RIDGE PORT NORTH 3RD ADDITION

RE: S/D 99-62 -- Final Plat of RIDGE PORT NORTH THIRD ADDITION

STAFF REPORT

CASE NUMBER: S/D 99-62 -- RIDGE PORT NORTH 3RD ADDITION

RIDGE PORT NORTH 3RD ADDITION

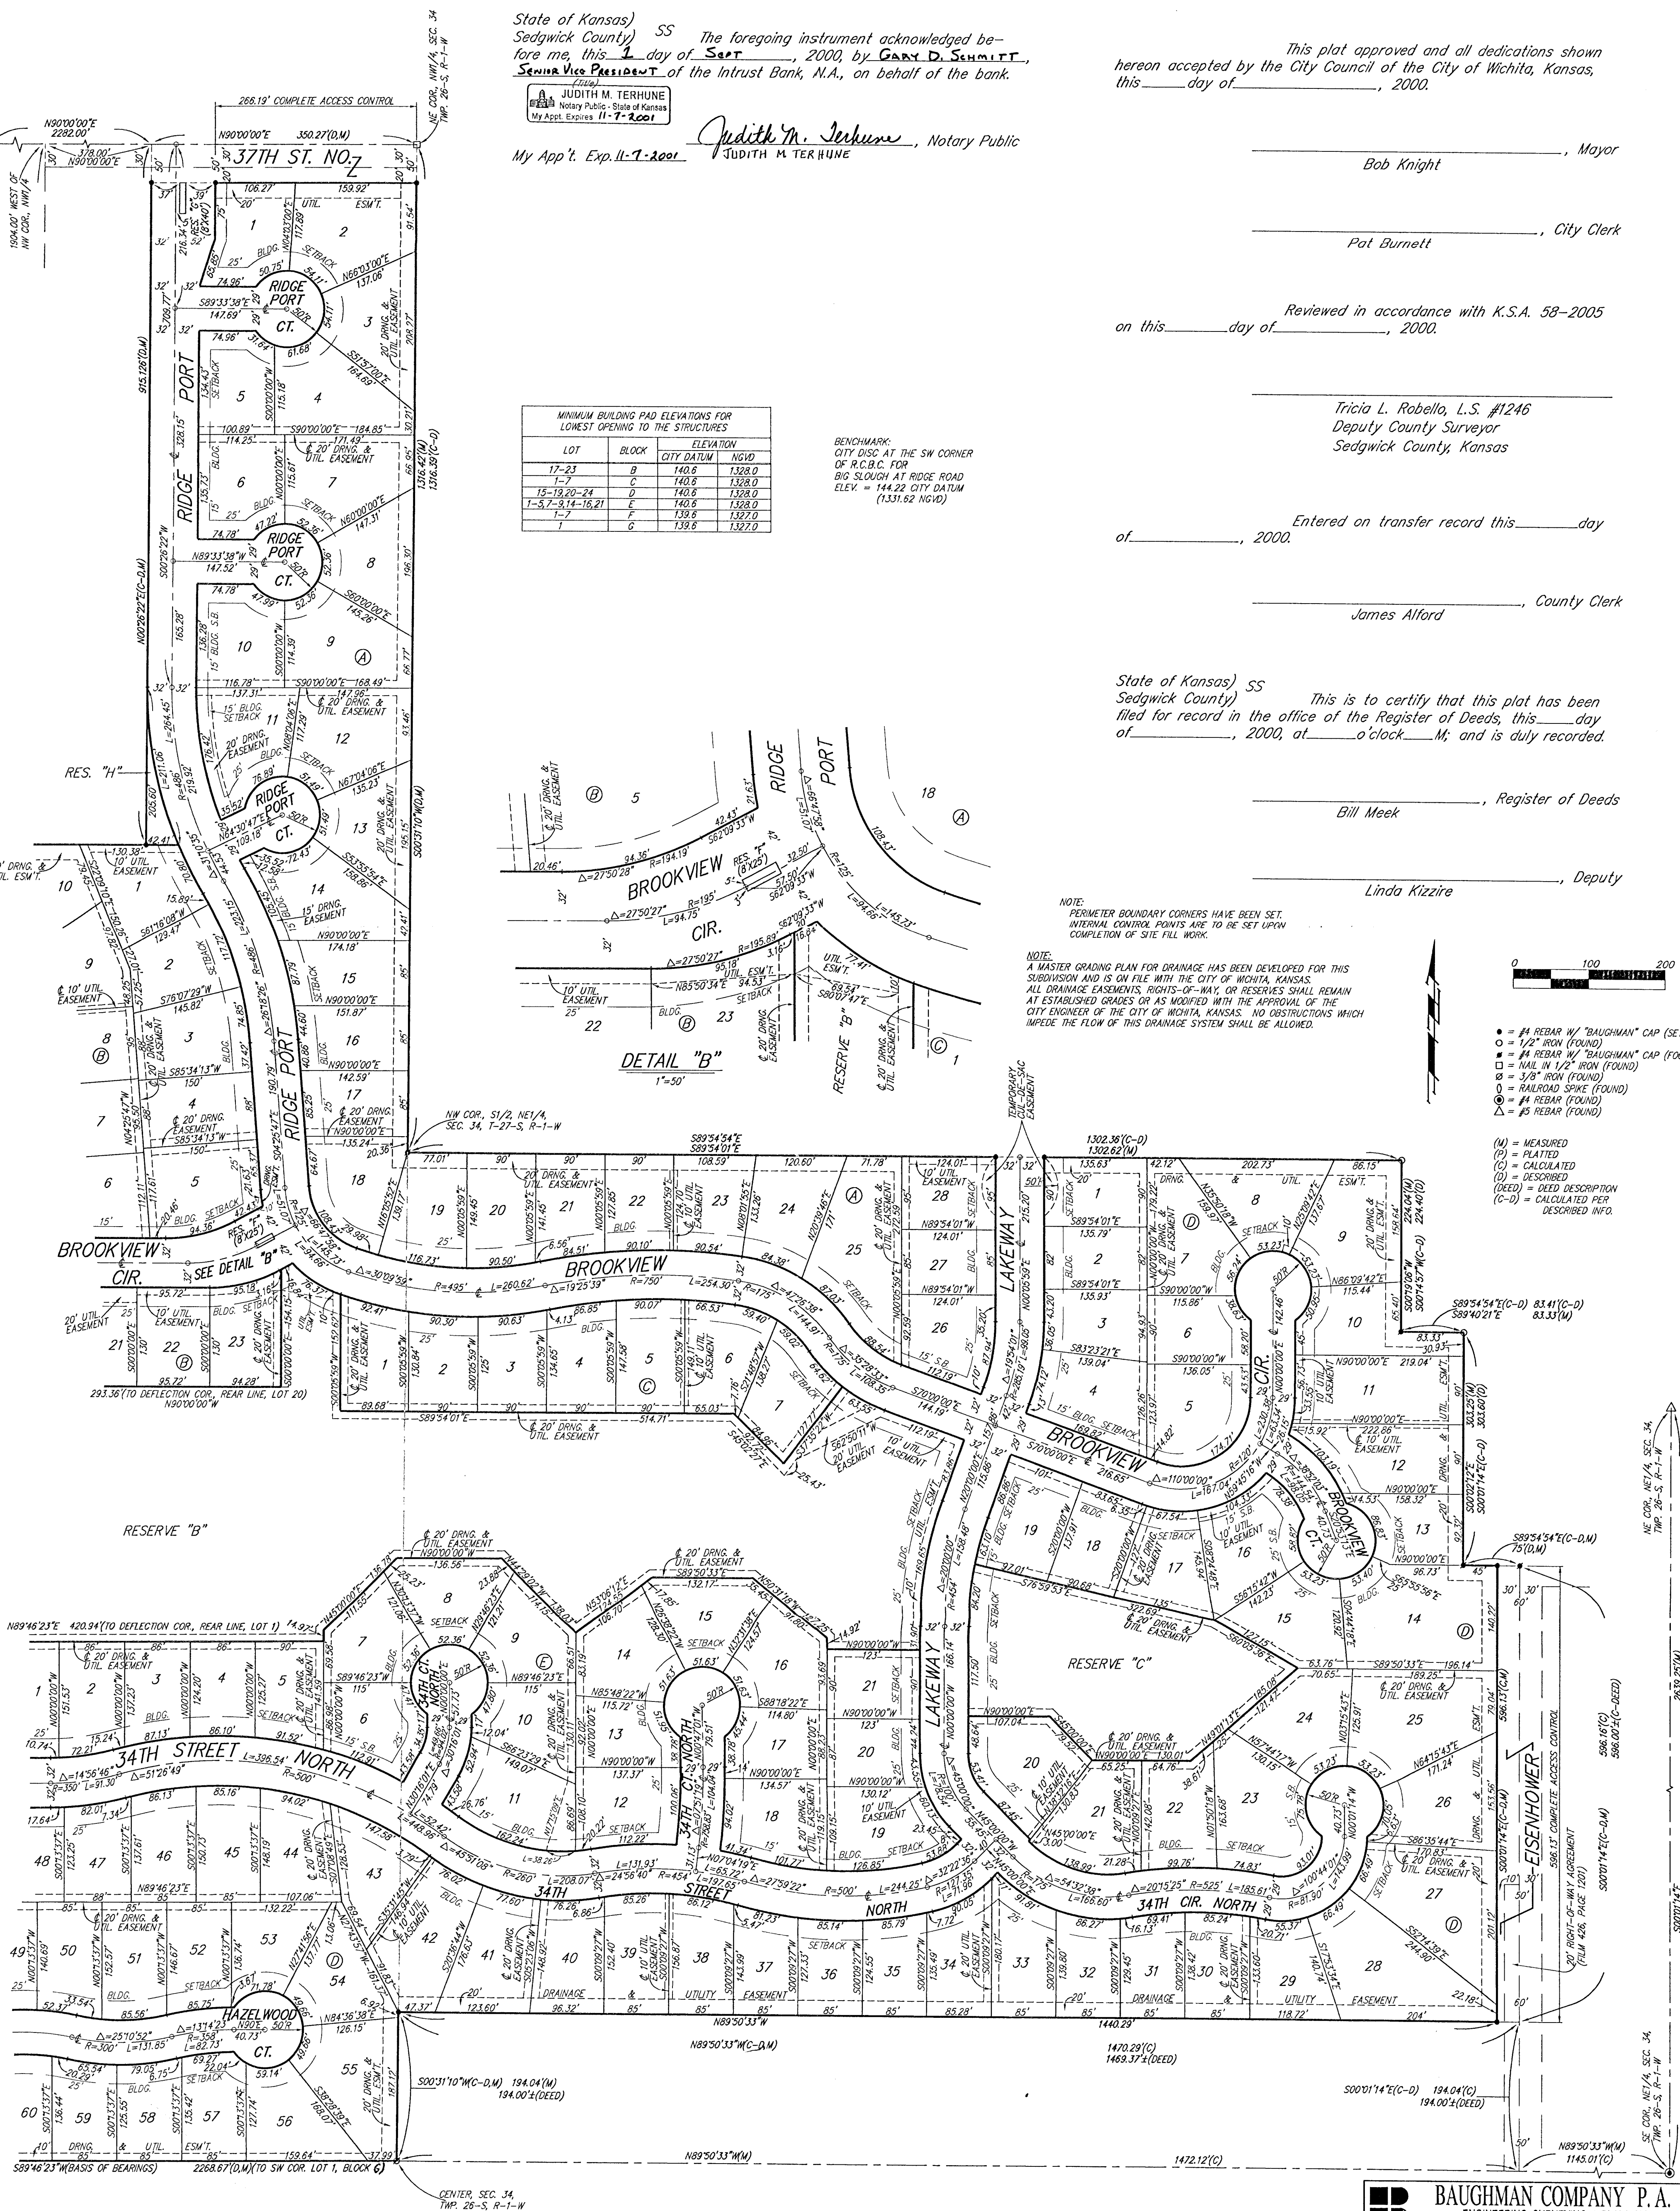
City Fire Department needs to comment on the plat's street names. The final plat tracing needs to indicate the following street name changes: 34th St. North Circle to 34th Circle North, and 34th St. North Court to 34th Court North.

- P. The dimensions on the north and south lines of Lot 27, Block 1, do not match the dimension on the north line of Lot 28, Block 1.

- Q. The triangular piece of land north of Lot 1, Block 2, needs to be labeled as a Reserve.
- R. This property is within a zone identified by the City Engineers' office as likely to have groundwater at some or all times within 10 feet of the ground surface elevation. Building with specially engineered foundations or with the lowest floor opening above groundwater is recommended, and owners seeking building permits on this property will be similarly advised. More detailed information on recorded groundwater elevations in the vicinity of this property is available in the City Engineers' office.

- P. The dimensions on the north and south lines of Lot 27, Block 1, do not match the dimension on the north line of Lot 28, Block 1.
- Q. The triangular piece of land north of Lot 1, Block 2, needs to be labeled as a Reserve.
